TO: Casey Adragna, Adragna Architecture
FROM: Amber Wood Hicken, Planner I
DATE: 5/5/25
SUBJECT: Douglas 234 Multitenant, Site Plan
Review Comments 01

SITE PLAN
HORSE CREEK COMMERCIAL
 LOT 10B, DOUGLAS 234 FILING NO. 6, AMENDMENT 2
 A PORTION OF THE SW 1/4, SE 1/4, SECTION 29, T6S, R66W, 6TH P.M.
 TOWN OF PARKER, COUNTY OF DOUGLAS, STATE OF COLORADO

COVER SHEET
 DOUGAS 234 FILING NO. 6, AMD. 2
 JOB NO. 24020
 DATE: FEBRUARY 12, 2025
 SHEET C1

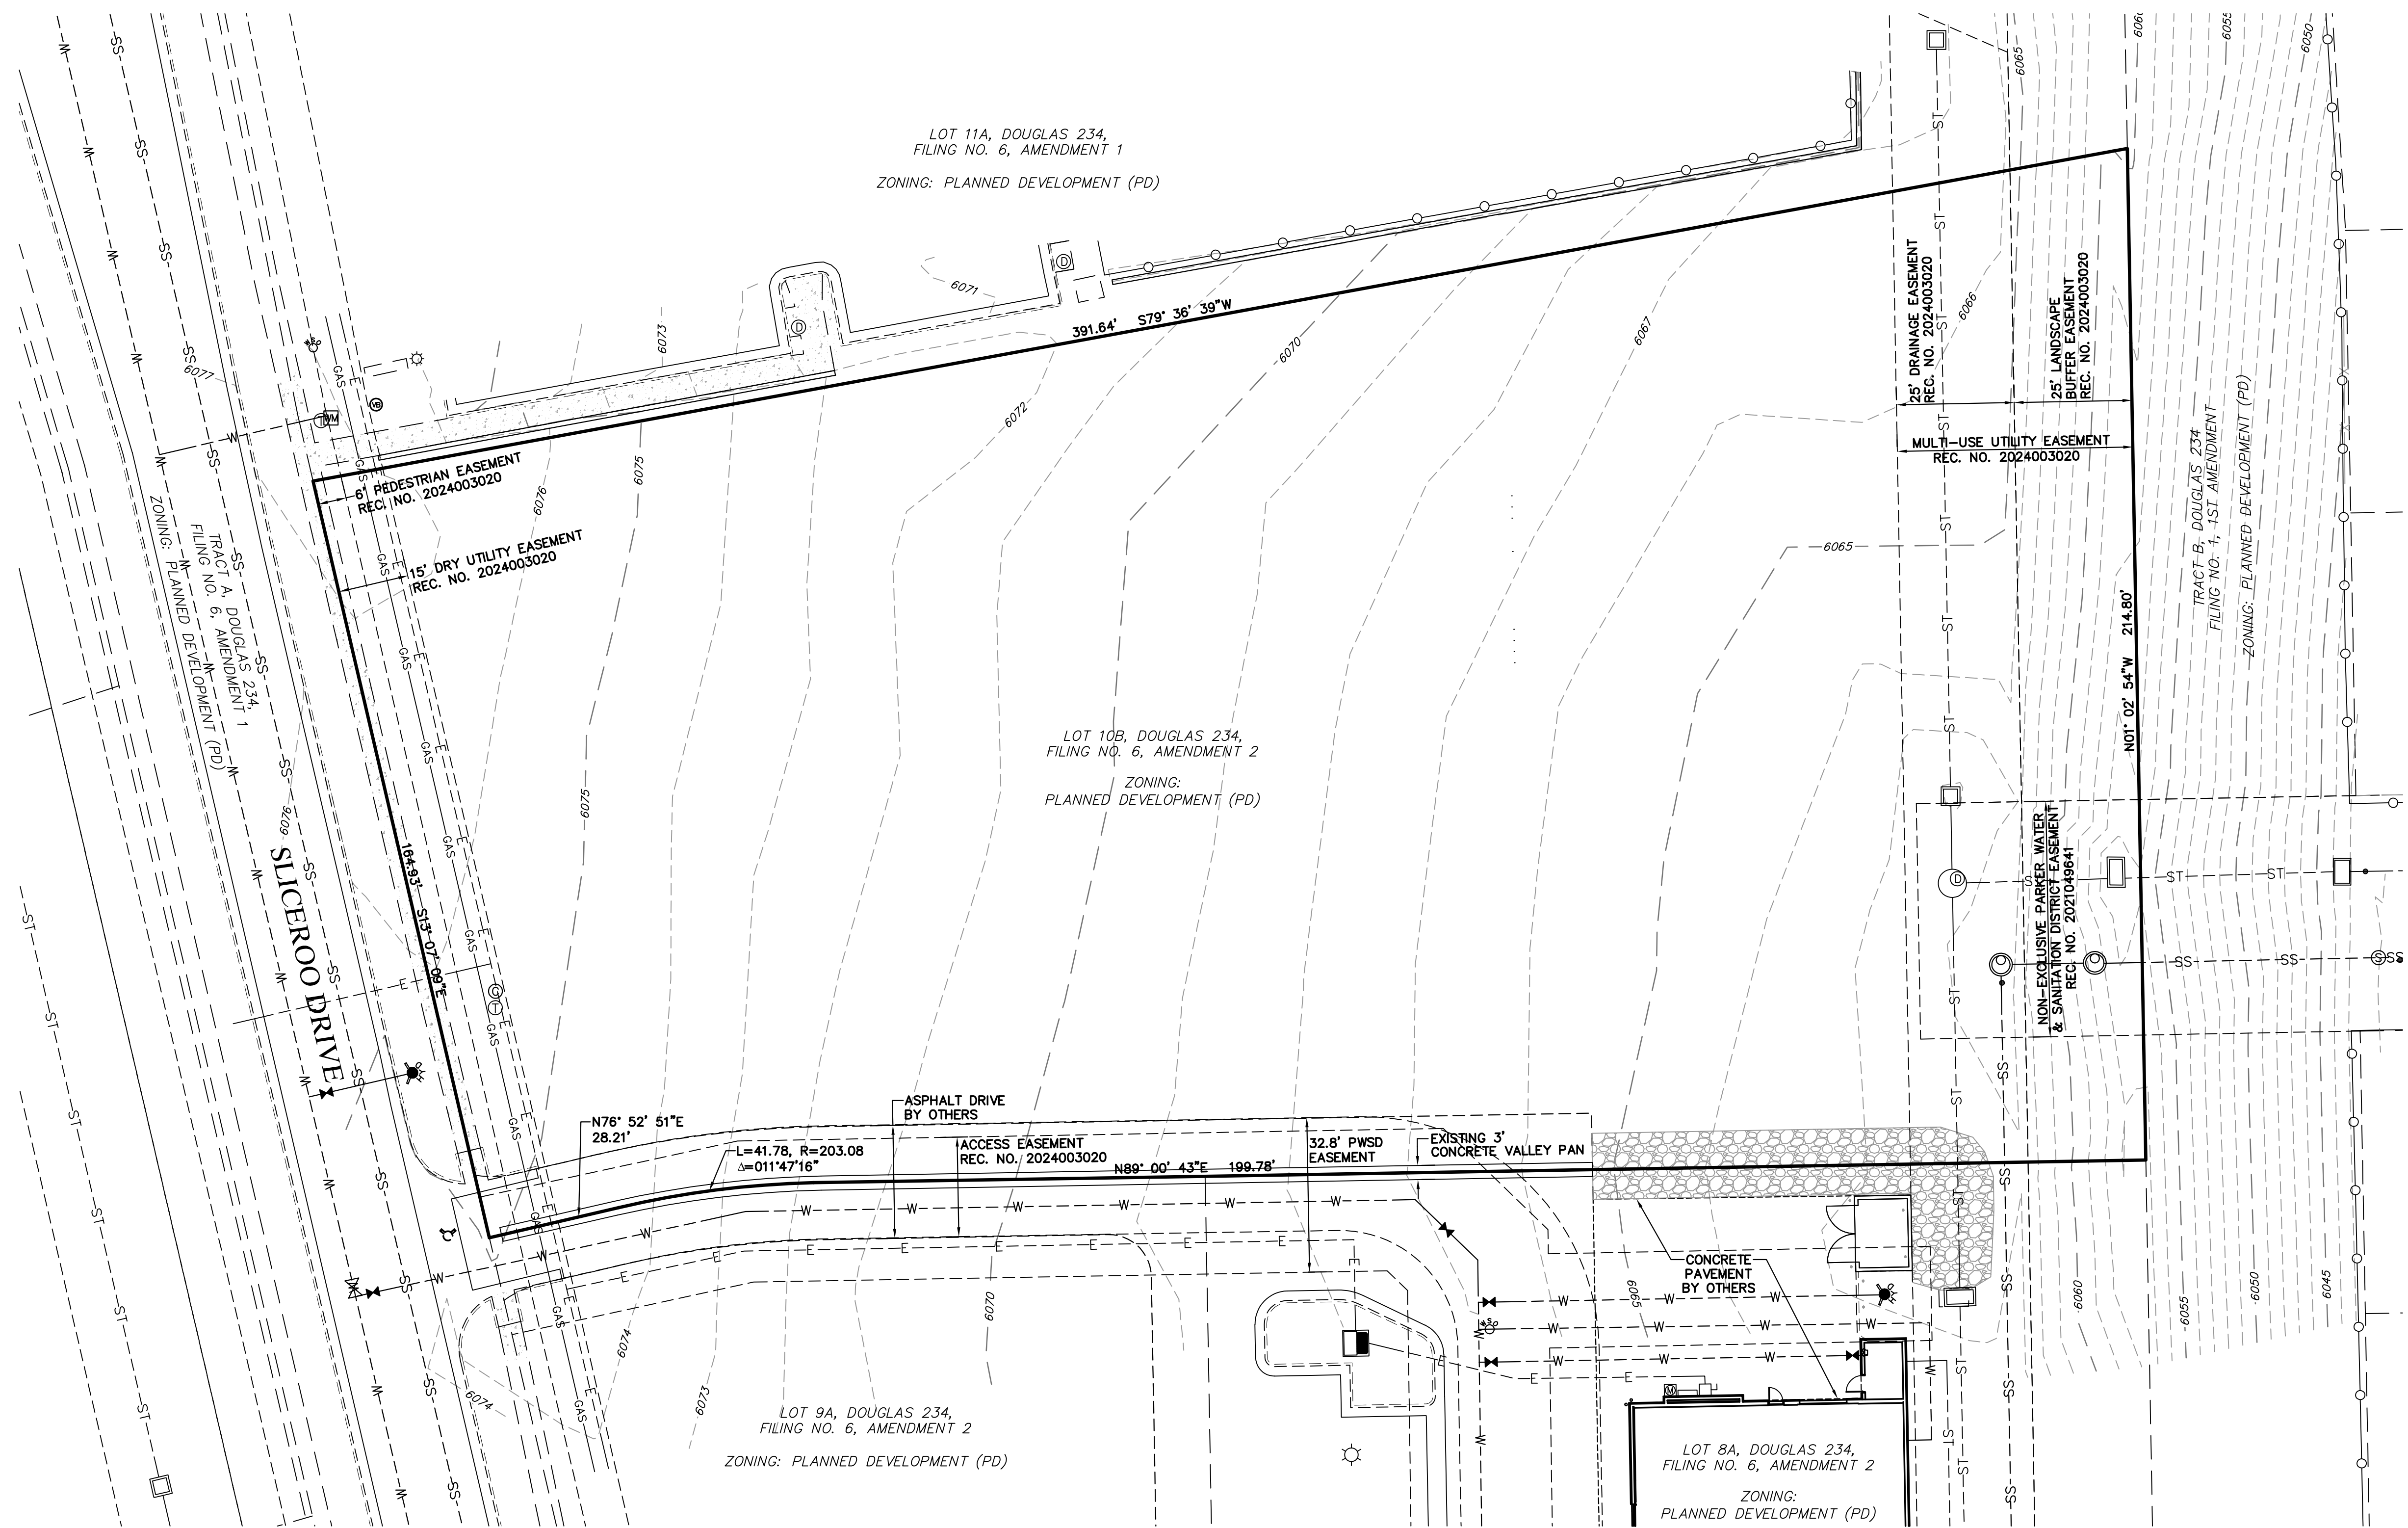
note - When used to calculate the maximum permitted height of a building, fence, or sign, grade means the average of the finished ground level measured at the center of each walls of the building.

add max height per PD - 60'

general retail over 10,000sf requires 1 space per 500 sf NLA

10' req

SITE PLAN
DOUGAS 234 FILING NO. 6, AMD. 2
JOB NO. 24020
DATE: FEBRUARY 12, 2025
SHEET C3

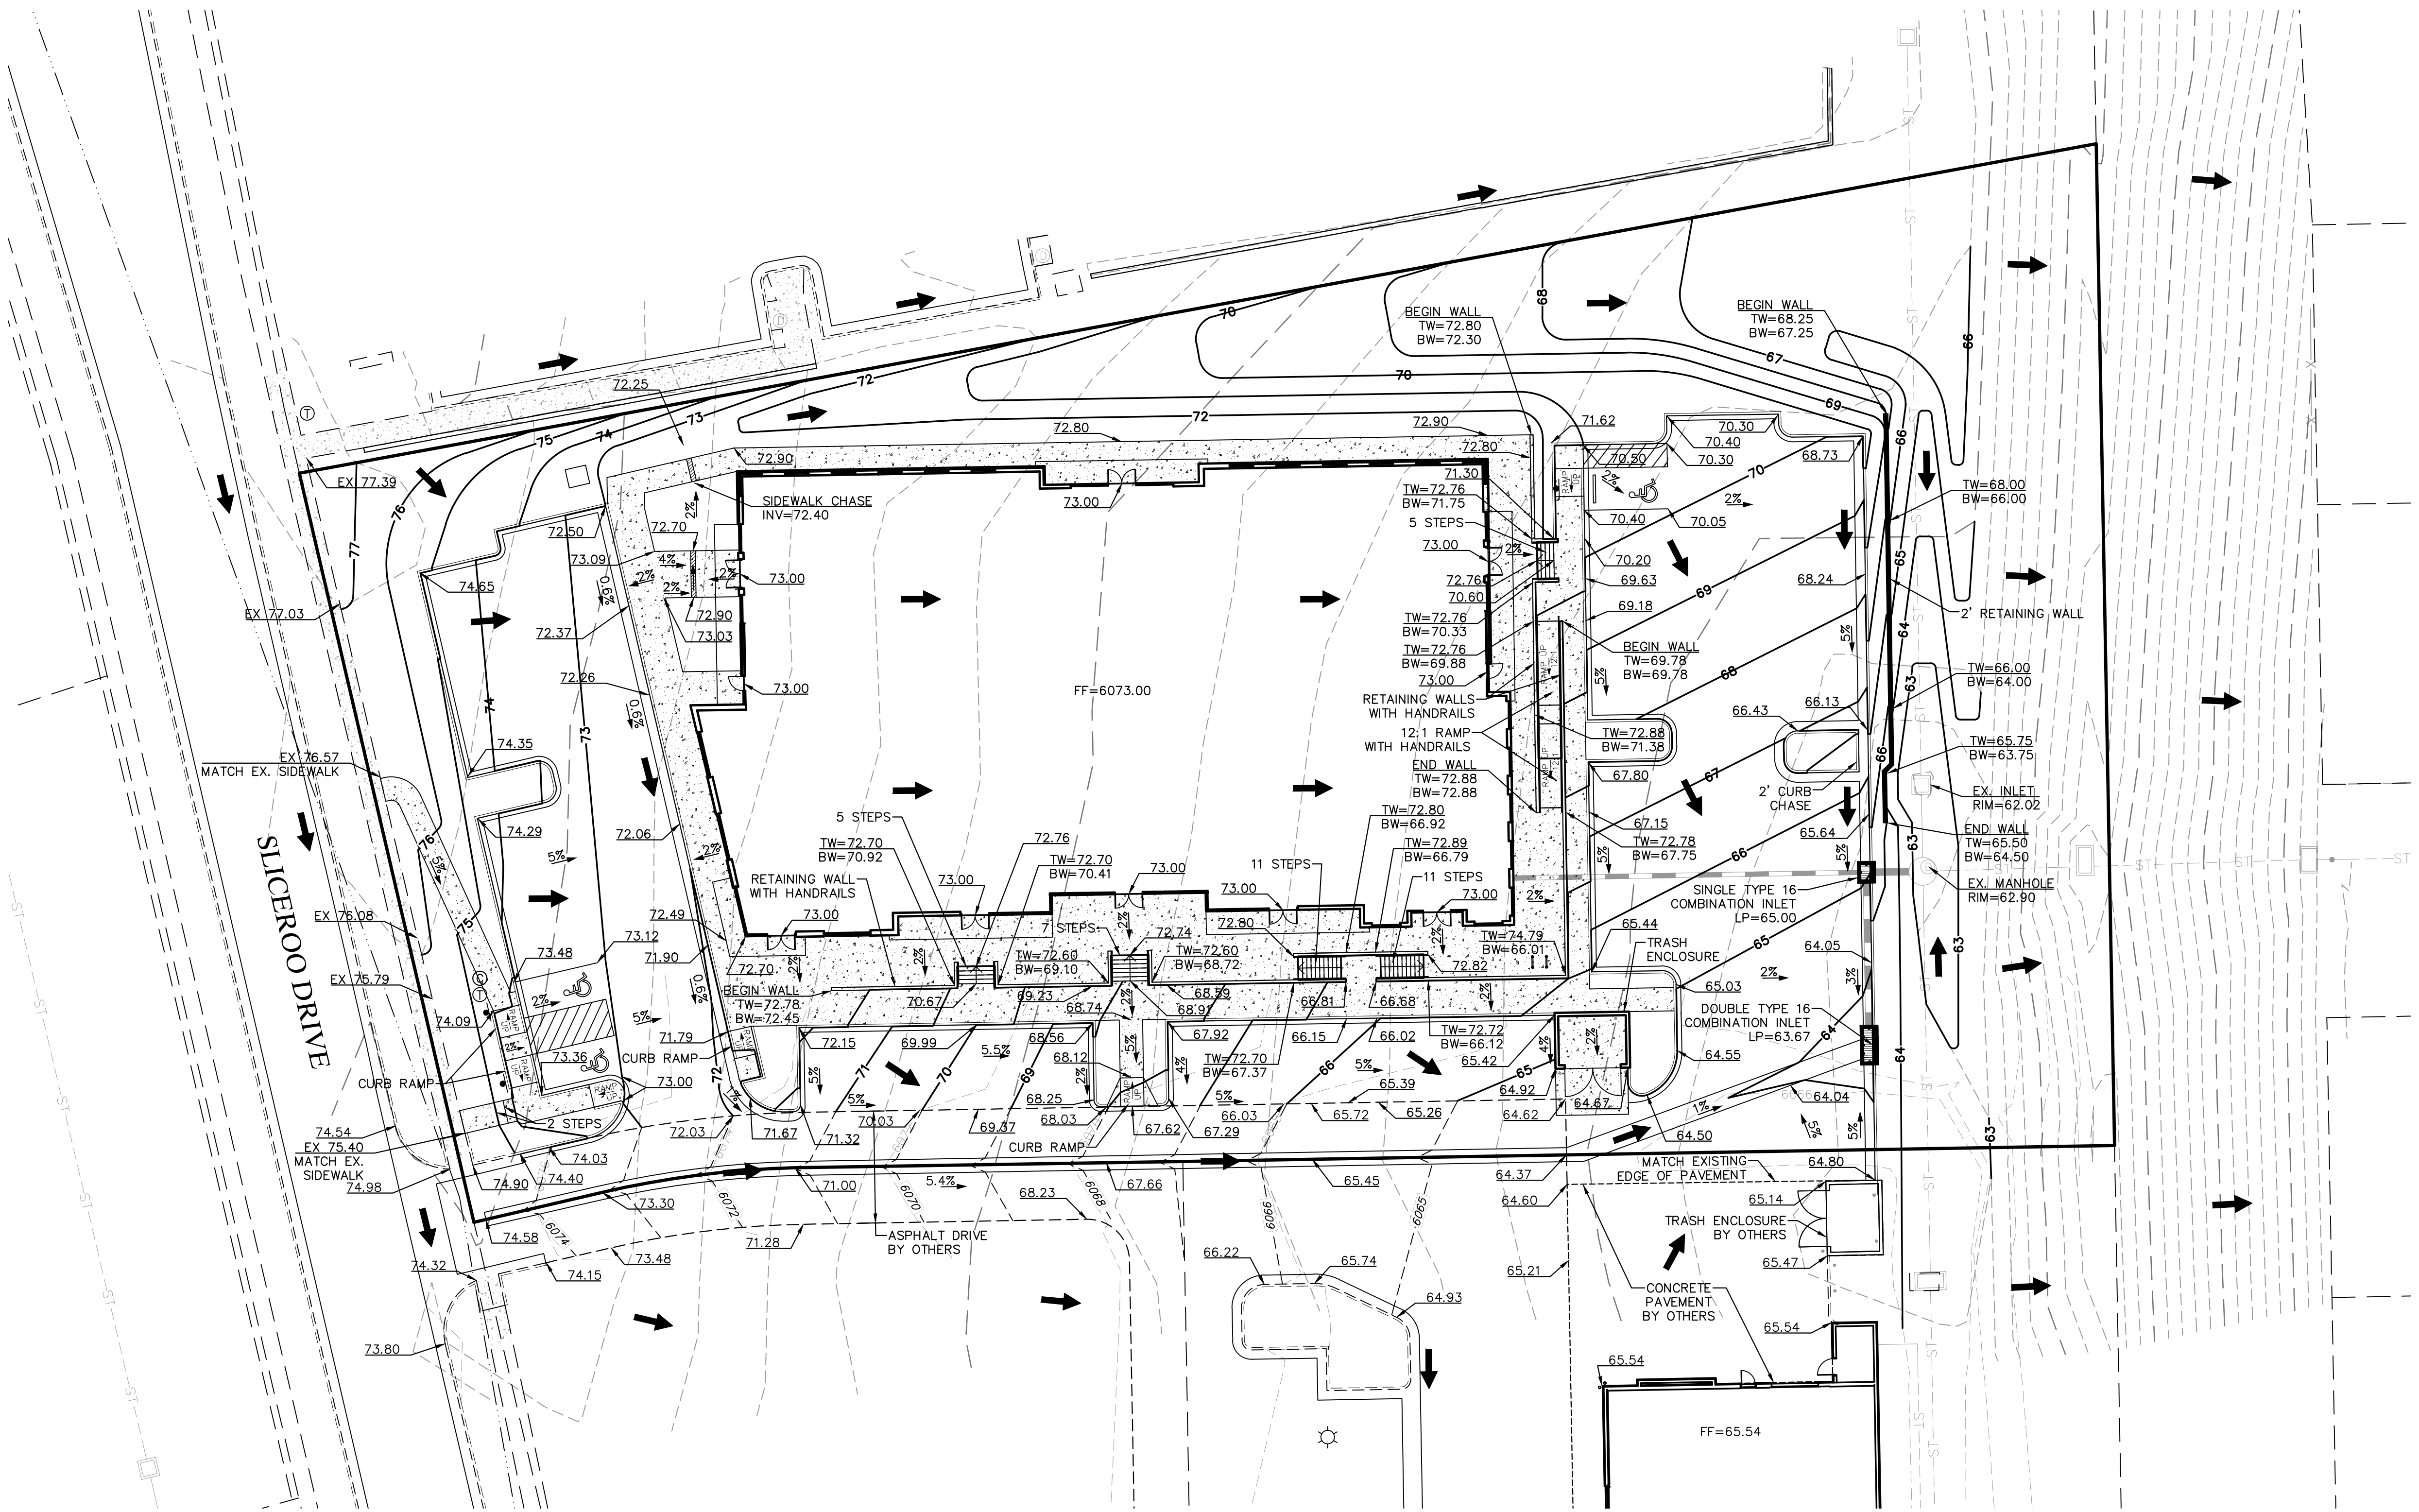
locate transformer
more internal to site
away from streets,
building fronts

retaining wall? label

possible to add stairs
here as well? access
to the building difficult
on west side

add line type for
retaining walls
add note - retaining
walls not to exceed 6'
in height

remove off-site
improvements/elements
will be reviewed with
that lot's site plan.
